Notice of Market Rules Modification

Paper No.: EMC/RCP/56/2011/303
Rule Reference: Market Rules/Chapter 6 Appendix D/Section 3 & Section 13A
Proposer: Energy Market Company
Date Received by EMC: 01 June 2011
Category Allocated: 1
Status: Approved by EMA
Effective Date: 17 November 2011

SUBJECT : **ELIGIBILITY OF REGULATION OFFERS**

Figure 1 GRFs which are able to reach SE_{T-1}

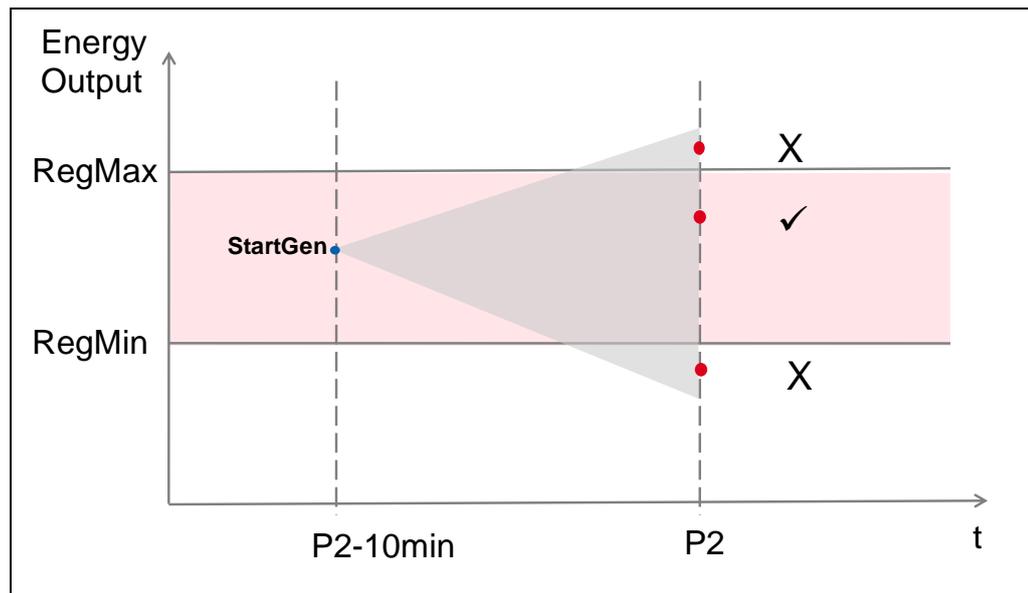
- (i) For a GRF which is able to reach its SE_{T-1} i.e. $(StartGen - SE_{T-1})/RampingTime^9 \leq DownRampRate$ AND $(SE_{T-1}-StartGen)/RampingTime \leq UpRampRate$, check whether its SE_{T-1} falls within its regulation range:

When $RegMin \leq SE_{T-1} \leq RegMax$ is true, then qualify.

This can be illustrated by Figure 1 below.

The grey shaded area represents a GRF's maximum and minimum energy output level given its StartGeneration value and its offered Up/Down ramp rate. If a GRF's SE_{T-1} (as represented by the red dots) falls within this range, it would be able to reach its SE_{T-1} . Since a GRF is obligated to (and able to) comply with its SE_{T-1} , it is then expected that the GRF's output at the beginning of Period 2 would be at SE_{T-1} . SE_{T-1} is then compared against RegulationMin/RegulationMax to determine if this GRF is eligible to provide regulation for Period 2.

Figure 2 GRFs which are not able to reach SE_{T-1}

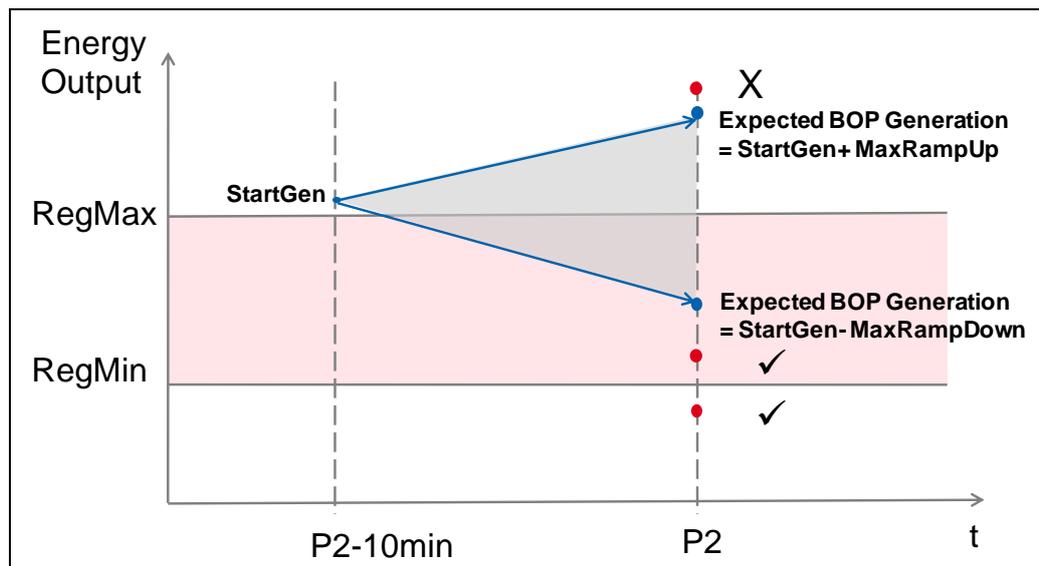
- (ii) For a GRF which is unable to reach its SE_{T-1} i.e. $(StartGen - SE_{T-1})/RampingTime > DownRampRate$ AND $(SE_{T-1}-StartGen)/RampingTime > UpRampRate$, it is assumed that the GRF would try to reach its scheduled energy by ramping up or down at its maximum rate. In this case, we would check whether it can enter into its regulation range when it is ramping up/down to meet its SE_{T-1} :

When $StartGen > SE_{T-1}$ AND $RegMin \leq StartGen - DownRampRate \times Ramping\ time \leq RegMax$ is true, then qualify.

When $StartGen < SE_{T-1}$ AND $RegMin \leq StartGen + UpRampRate \times Ramping\ time \leq RegMax$ is true, then qualify.

Figure 2 below illustrates how this test works when the SE_{T-1} is not reachable. As shown in the diagram, if the GRF is ramping up at maximum rate to meet its scheduled energy, its expected generation level at the beginning of P2 would be $StartGen + UpRampRate \times RampingTime$. We will then check if this value is within the regulation range to determine if this GRF is qualified to provide regulation. Similarly, if a GRF is ramping down, its expected generation level at the beginning of P2 would be $StartGen - DownRampRate \times Ramping\ time$. The value is then checked to ascertain if it is within the regulation range, in order to qualify this GRF for regulation provision.

In summary, the proposed two-part BOP test would project a GRF's generation level at the beginning of a dispatch period taking into account of its schedule ($SE_{(T-1)}$) and its physical constraints (i.e. StartGeneration and ramp rates) instead of relying only on its StartGeneration which captures the GRF's generation level at 10 minutes before the beginning of a dispatch period. When such physical constraints allow the GRF to meet its $SE_{(T-1)}$, $SE_{(T-1)}$ would be the expected generation level at the beginning of a dispatch period and be used to test if the GRF is within the regulation range. When these physical constraints do not allow the GRF to meet its $SE_{(T-1)}$, then the expected generation level at the beginning of a dispatch period is determined with its StartGeneration with maximum ramp up/down rate.

Figure 3: No Shortfall in Regulation Provision

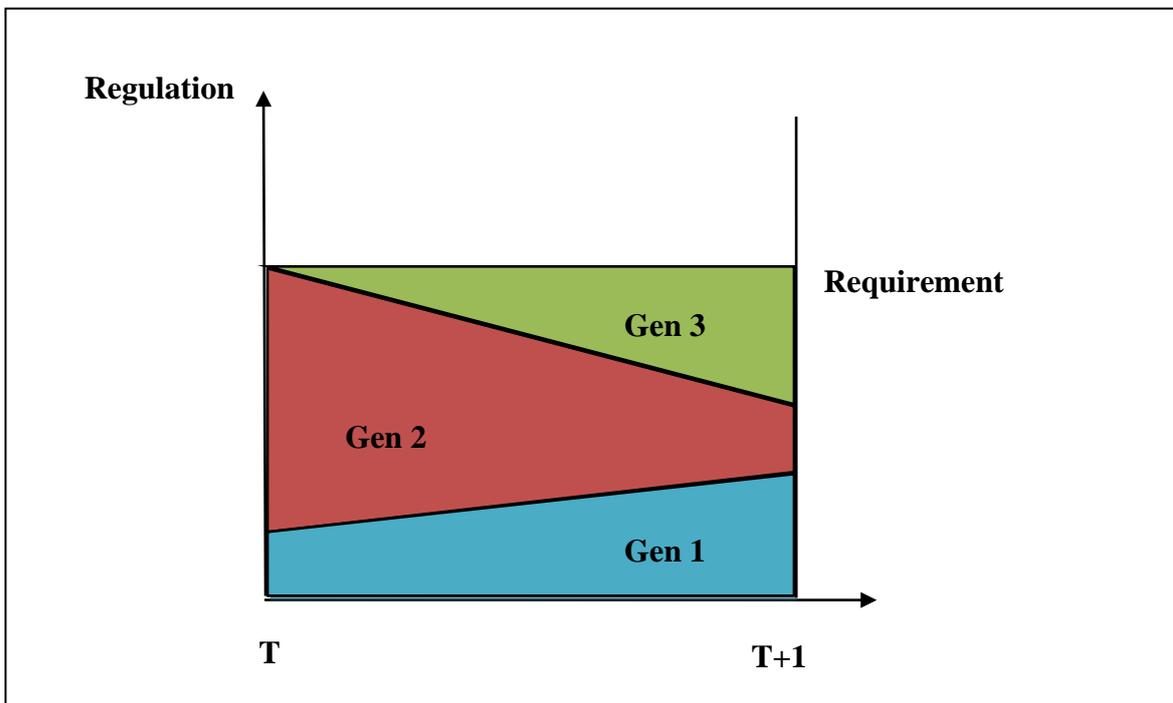
We agree that this argument is valid, on condition that GRFs remains within the range which they can provide the ancillary service throughout the dispatch period i.e. in the case of regulation provision, the GRFs should be within its regulation range from the beginning to the end of the dispatch period.

This is because, when we look at the whole set of GRFs providing regulation, the GRFs' aggregate regulation contribution will sum to the total regulation requirement at the end of each dispatch period – so long as the GRFs' are all able to ramp linearly AND provide regulation throughout the dispatch period, with some GRFs ramping down just as other GRFs are ramping up regulation contribution, there will be no shortfall in regulation provision for that dispatch period. This is illustrated by Figure 3 below.

Figure 4: Shortfall in Regulation Provision

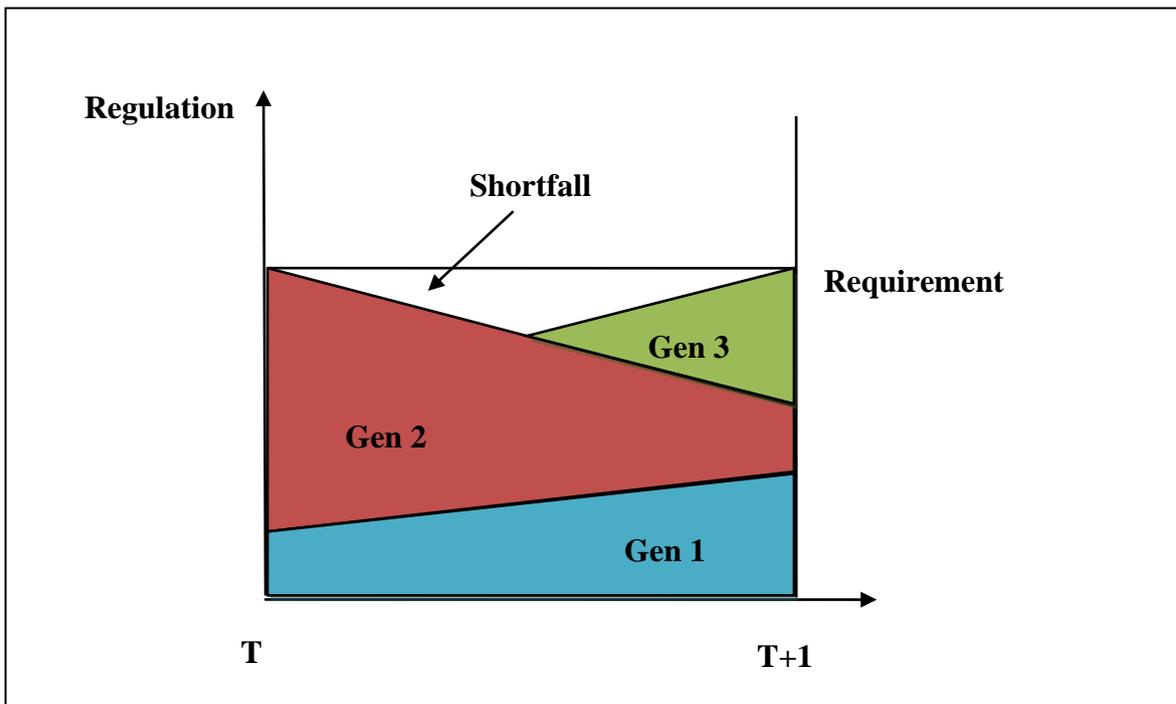
Conversely, if during the dispatch period, some GRFs are ramping into their regulation range or other GRFs are ramping out of their regulation range – these GRFs are not able to provide regulation for parts of that period and a shortfall in regulation provision could be created for that period. This is illustrated by Figure 4 below.

Our study in section 4 evaluates the results of removing the BOP test, i.e. only the EOP test is applied, on regulation provision by GRFs and system-wide regulation shortfall. This will let us observe whether the EOP test alone is sufficient to ensure that GRFs scheduled to provide regulation are able to do so throughout a dispatch period.
